DEPARTMENT OF PLANNING AND COMMUNITY DEVELOPMENT

CASE NOS.: 06-CUP-005 and 06-OTP-008 (Amendment)

LOCATION: 6160 Fairview Place
(A.P.N. 2055-023-109)

REQUEST: Request for approval of a Conditional Use Permit and Oak Tree Permit Amendment for changes to the approved grading plan and associated changes to the landscape plan.

Photo 3 – Front Retaining Wall

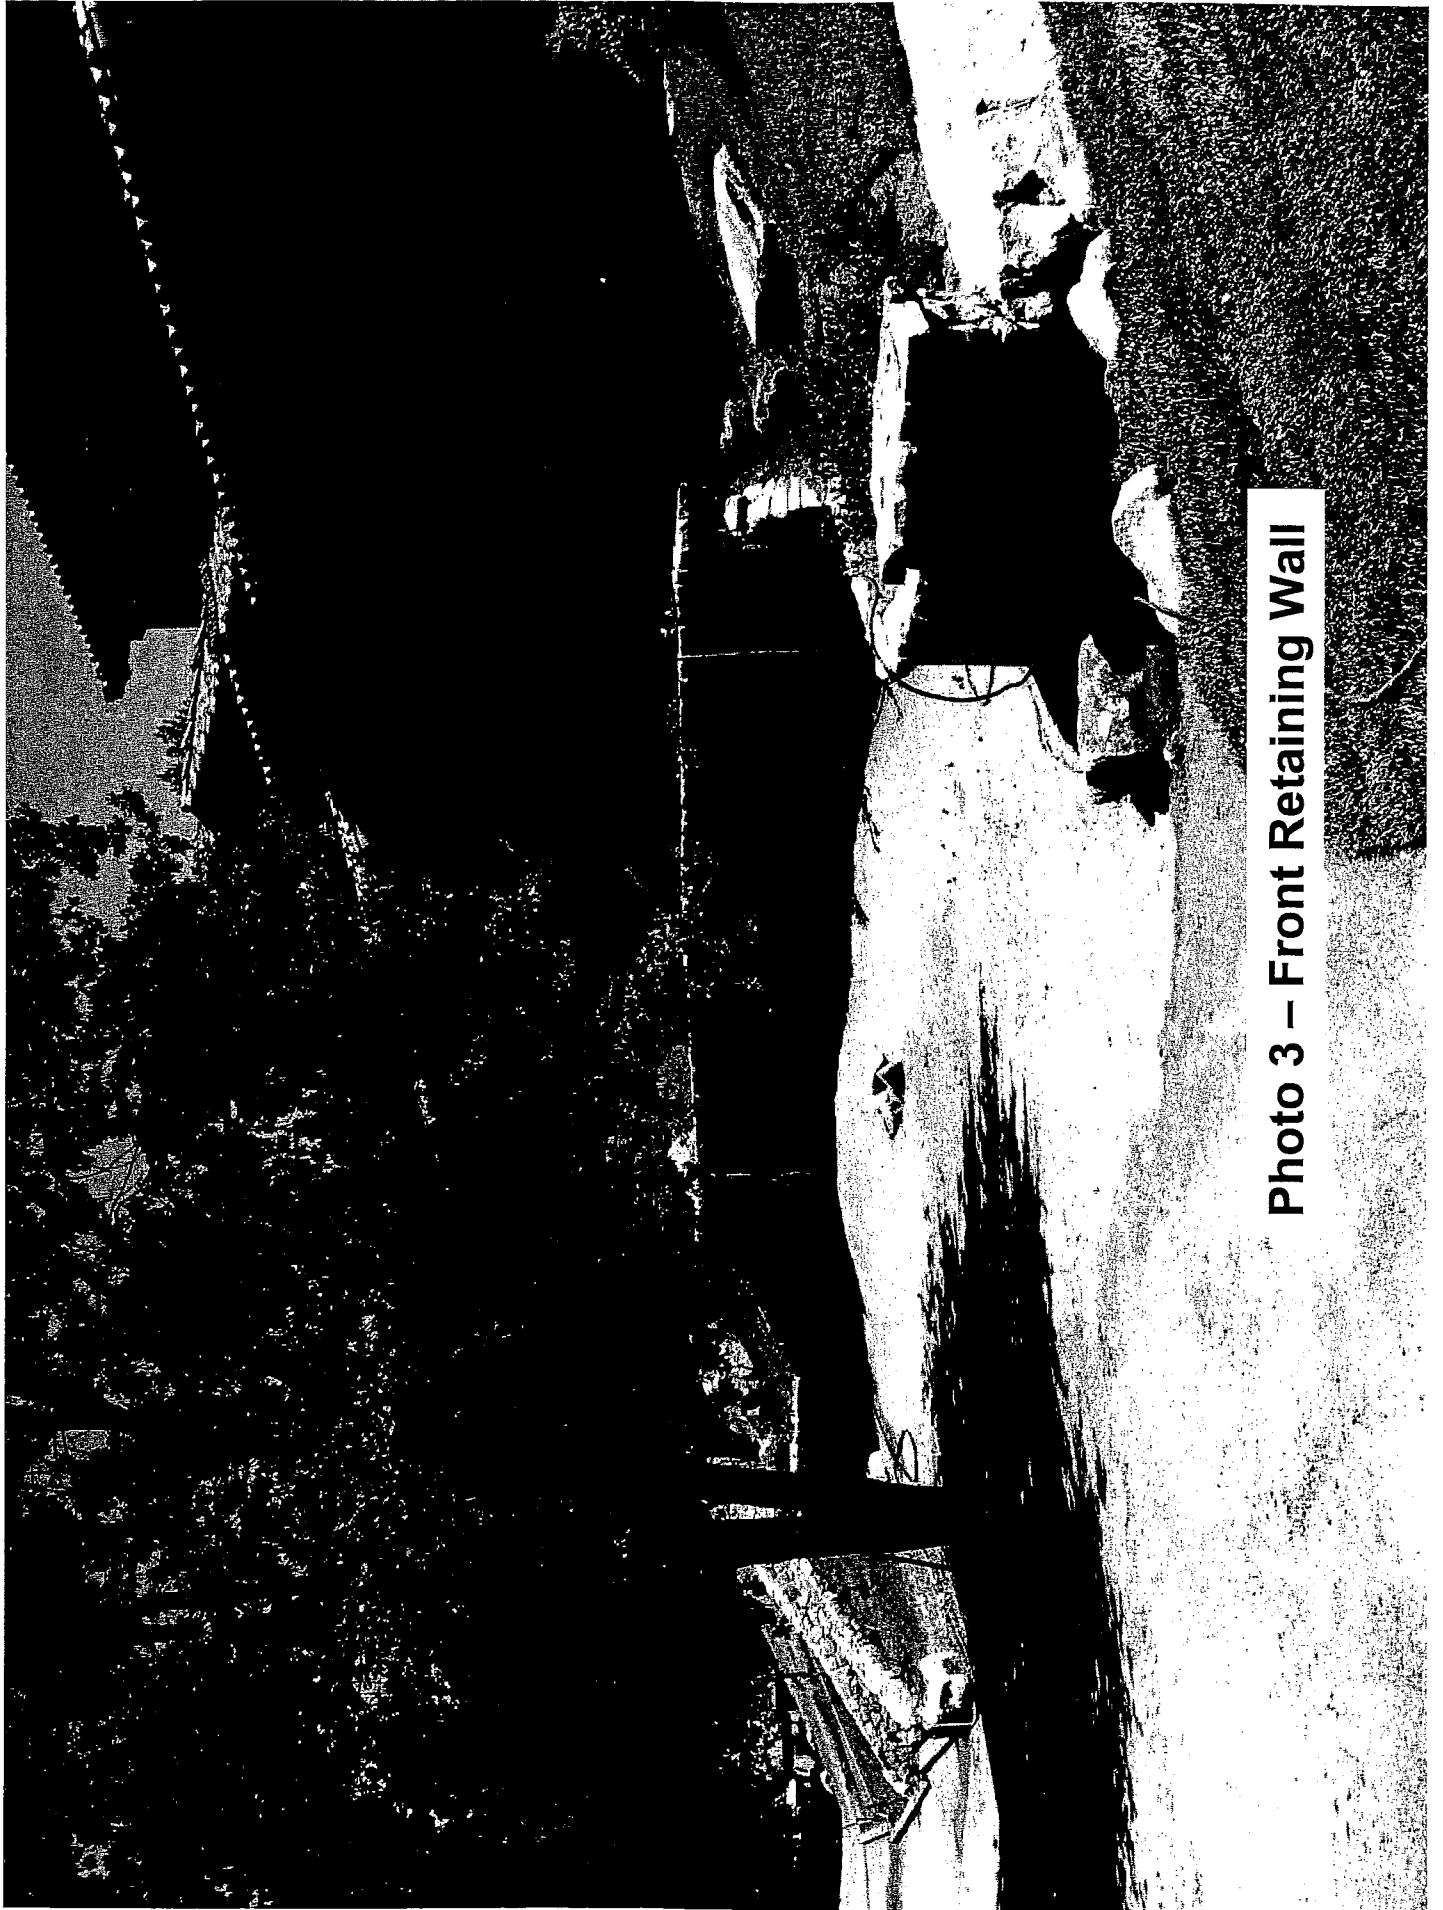
3. Front Retaining Wall. The front retaining wall was moved inward slightly (between a few inches and 2 feet) to protect the oak tree it surrounds from encroachment into the “protected zone”, which ranges five feet outward from the drip line (outermost branches) of the tree. Such encroachment is prohibited by the CUP and the City’s Oak Tree Ordinance. (See A.H.M.C. secs. 9657-9657.5 and Appendix A (Oak Tree Preservation Guidelines.) The wall was also lengthened to accommodate the revised stairway and to account for the elimination of the planter walls in this area. (See item 4, below.) As with the original approved wall, the revised wall is no taller than 6 feet, meeting the requirements of the City’s code. (See A.H.M.C. sec. 9606.2(D).)

Photo 4A – Planter Walls

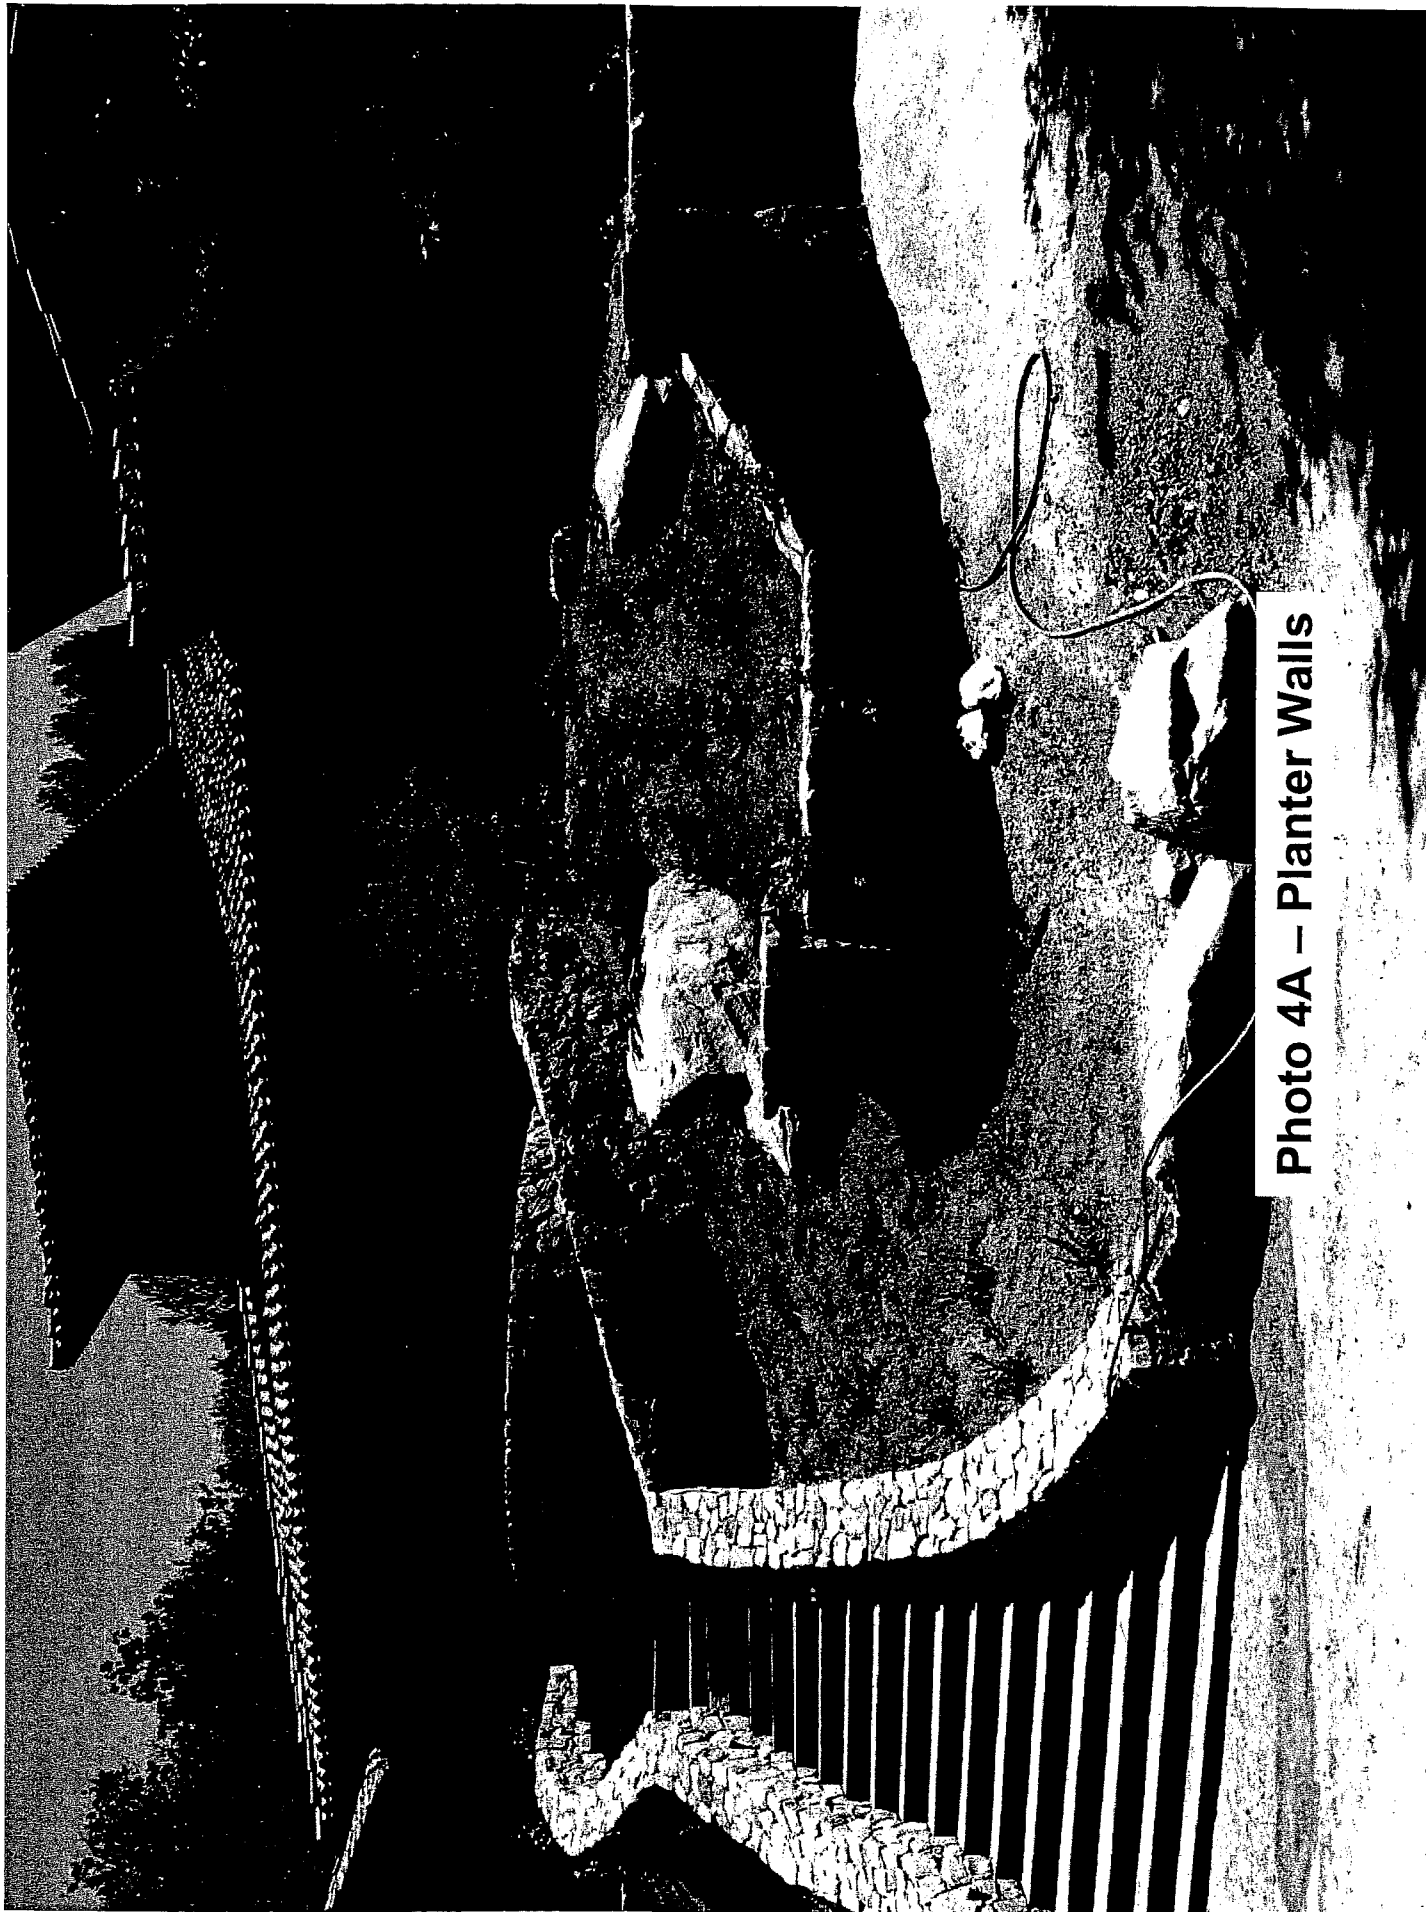
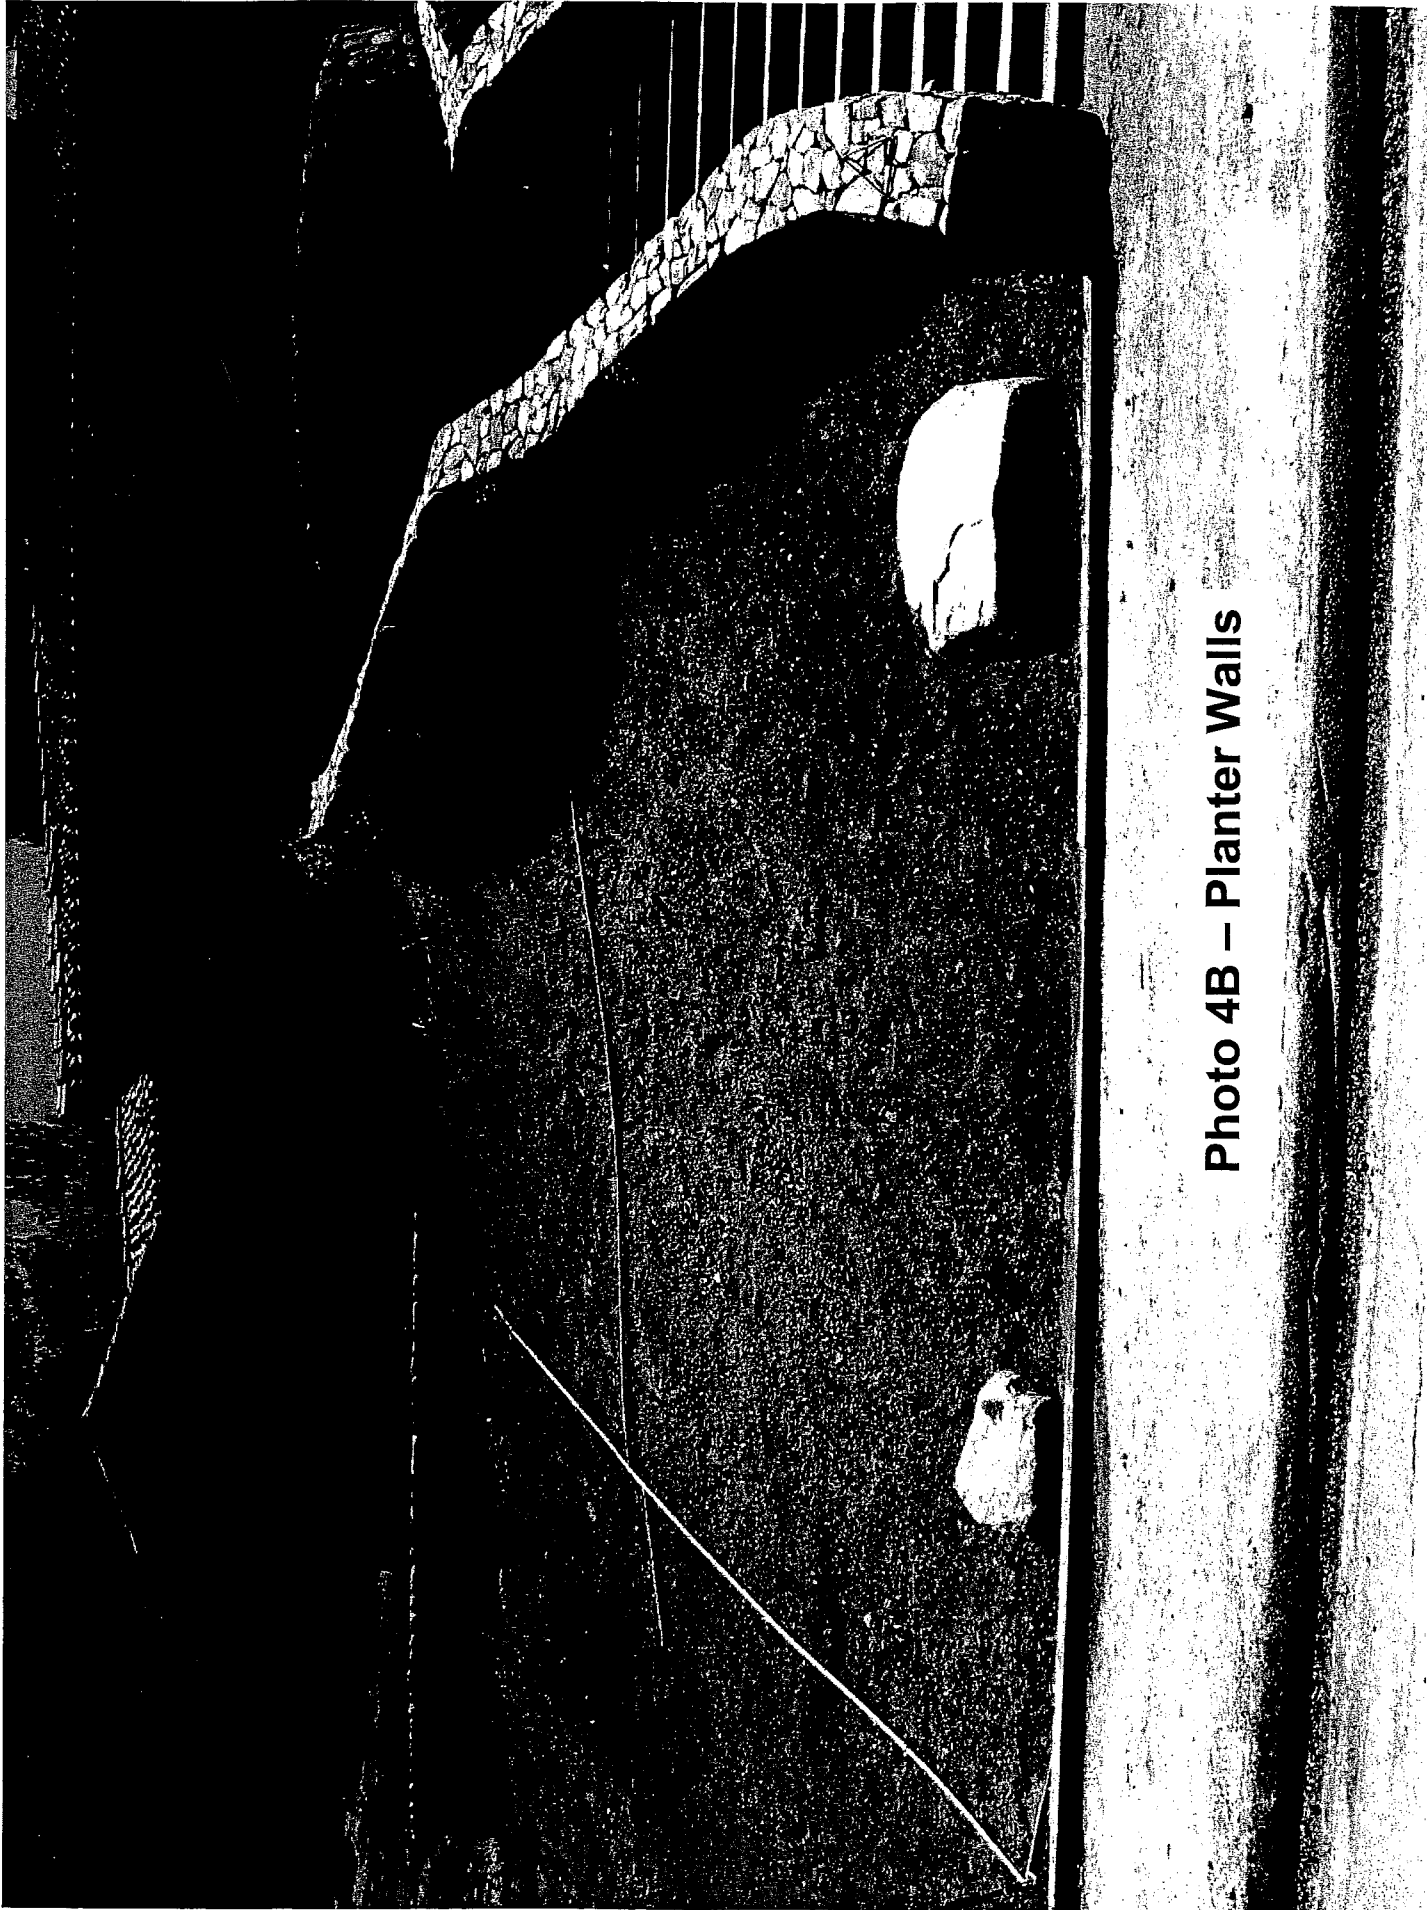
stairway (which had linked to the original stairway design) and left these areas vegetated in a natural slope. (See Photos 4A, 4B.)

4. Planter Walls. The three decorative planter walls removed from the front yard reduce the amount of grading needed in the front yard and make the front yard conform better to the natural contours of the land. This is consistent with the City’s zoning ordinance. (See A.H.M.C. sec. 9553.1(C)(8) (for purposes of site plan review, “To the greatest extent possible, the architectural design and location of the building shall discourage grading on a hillside”); sec. 9652.5 “The intention and policy of the city is to: 1. Encourage minimal grading which relates to the natural contours of the land as opposed to padding or staircase grading.”)

Photo 5 - Pilasters

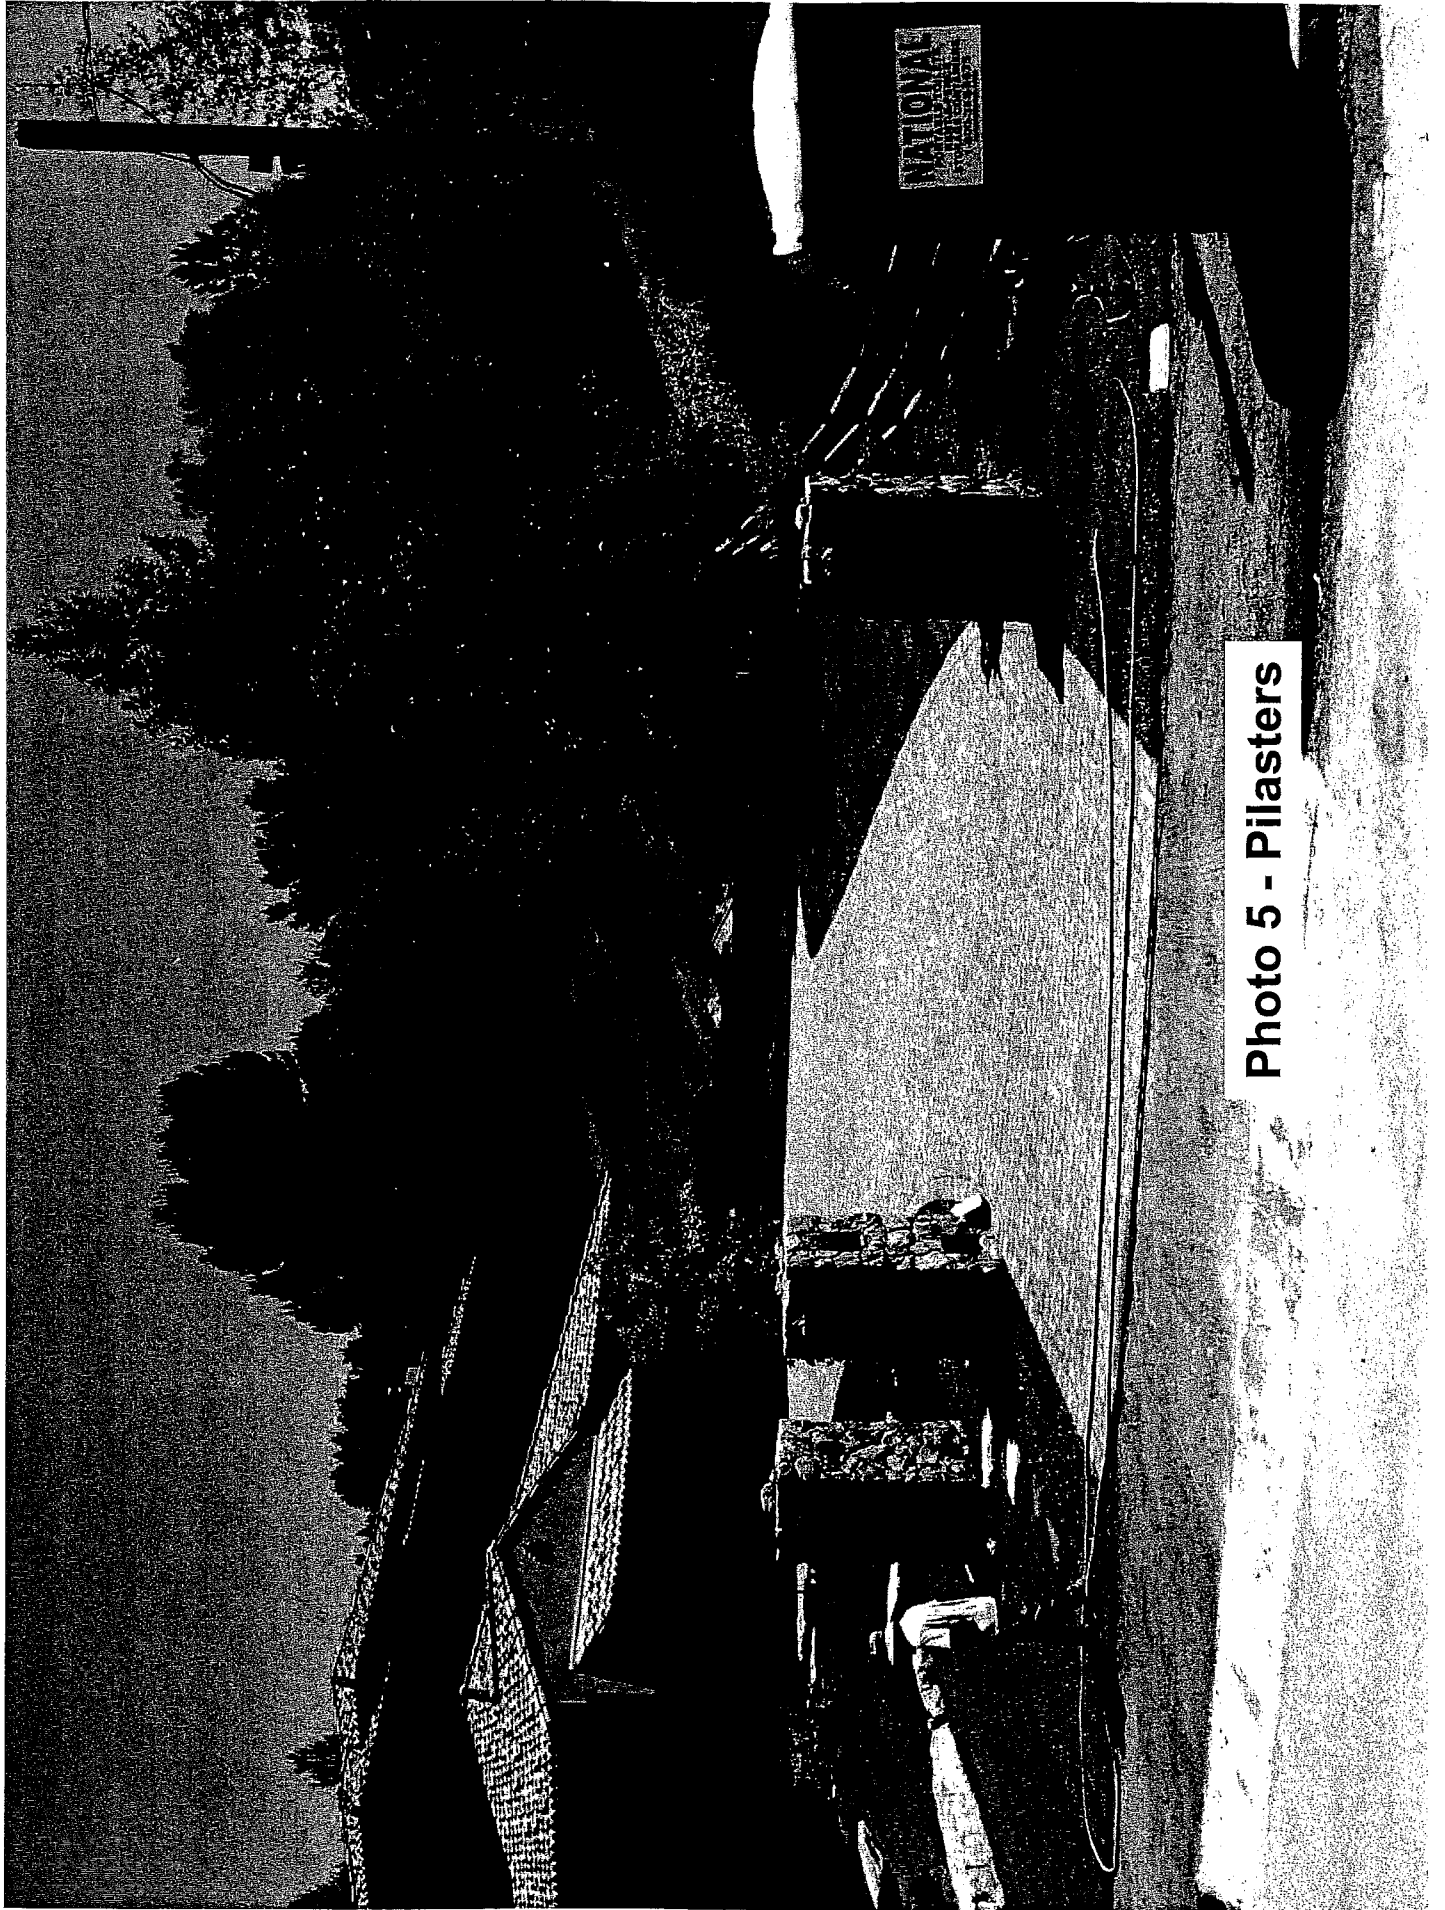
5. Pilasters. He moved the two pilasters originally approved on either side of the driveway to parallel the curb, and added a third pilaster to allow for a walking gate. (See Photo 5.)

5. Pilasters. The relocation of two pilasters, and the construction of a third to allow for a walking gate, are consistent with good design and sufficiently minor that they would not require a discretionary approval if proposed separately.
